# Access Compliance Report

## Public Rights-of-Way

Intersection ID: 49197	Main Street: GRAYPARK_DR	Cross Street: ALEXANDER_FOREST_DR	Location: S
ADA ID: B13E9466E392	Ramp Type: PerpDiag	Initial Pass/Fail: Pass	Overall Compliance: No
Severity Score: 7.75			
Codes/Mitigation Info/Possible Solution		Field Measurements/Component Compliance

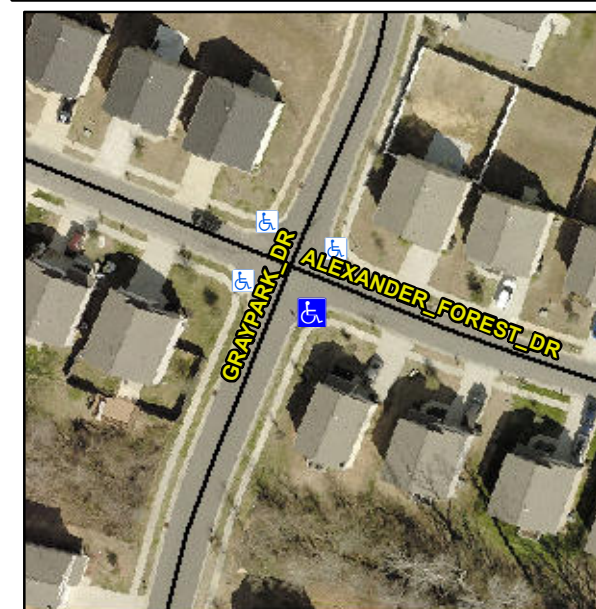
**Not Found, R304.5.3, R304.2.1, R305.2, R302.7.2**

Compliance	Description	Data	Compliance	Description	Data
N/A	Ramp Length (in)	48.0	Yes	Ramp Slope (%)	6.5
Yes	Ramp Width (in)	48.0	No	Ramp XSlope (%)	2.6
N/A	Flare Type LT	Sloped	N/A	Flare Type RT	N/A
N/A	Flare Slope LT (%)	1.6	N/A	Flare Slope RT (%)	7.4
N/A	Flare Traversable LT?	No	N/A	Flare Traversable RT?	No
No	Landing Length (in)	45.5	Yes	DWS Provided?	Yes
Yes	Landing Width (in)	48.0	Yes	DWS Contrast?	Yes
Yes	Landing Slope (%)	0.6	Yes	DWS Length (in)	24.0
Yes	Landing X Slope (%)	1.9	Yes	DWS Full Width?	Yes
N/A	Landing Curb? (Y/N)	No	No	DWS Offset (in)	4.0
N/A	Shared Landing?	No			
Yes	Gutter Ponding?	No	Yes	Gutter Slope (%)	3.0
No	Gutter Lip Ht (in)	0.5	Yes	Gutter X Slope (%)	1.3
N/A	Painted X Walk1?	No	N/A	Painted X Walk2?	No
	X Walk 1 Direction	To NE		X Walk 2 Direction	To NW
N/A	X Walk 1 Width (in)	N/A	N/A	X Walk 2 Width (in)	N/A
	X Walk 1 Slope (%)	1.7		X Walk 2 Slope (%)	3.0
	X Walk 1 X Slope (%)	3.6		X Walk 2 X Slope (%)	1.9

N/A	Ramp inside XWalk1?	N/A	N/A	Ramp inside XWalk2?	N/A
	Road Slope (%)	0.5	N/A	Clear Space?	Yes
	Road X Slope (%)	4.7	N/A	Clear Space to XWalk (in)	N/A
Yes	Any Obstructions?	No	Yes	Storm Grate/Utility Hazard?	No
	Obstruction Type			Storm Grate/Utility Type	
		N/A			N/A
			Yes	Surface Condition? (G/P)	Good

**Remove & Replace Curb Ramp With Two New Directional Ramps or Equivalent.**
